MERCURY
MARINER
MERCURY Sport Jet
FORCE Outboards

☑ ADVISORY
☐ BULLETIN

No. 99-1

V-6 POWER TRIM MOTOR HARNESS

a - Power Trim Harness
b - Conduit P/N 32-828547353
c - Sta-Strap P/N 54-816311

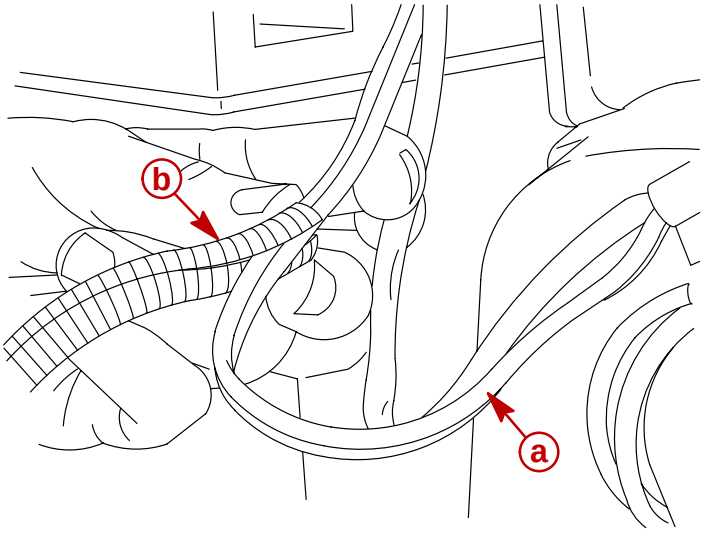
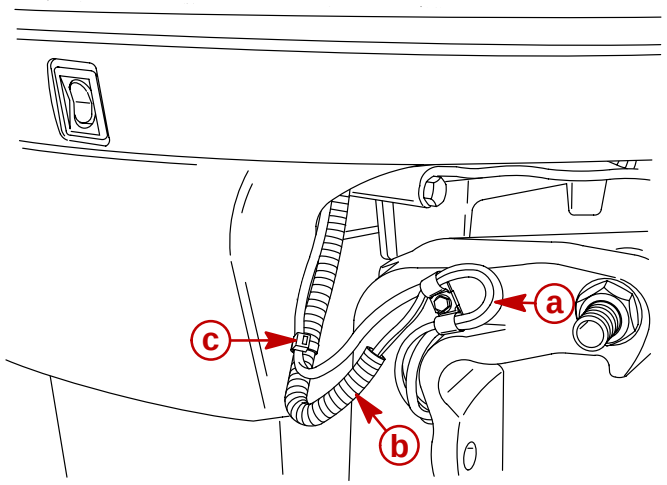
In some isolated cases contact between the power trim motor harness and the bottom cowl has been reported by our Technical Account Managers. This condition over time could cause chaffing of the motor harness. When servicing outboards within this group, it is recommended conduit **P/N 32-828547353** be installed over the motor wires between the adapter plate and starboard clamp bracket. This will provide added protection against chaffing. **DO NOT** include the trim sender wire within the protective conduit. Sta-strap the conduit to the trim sender wire.
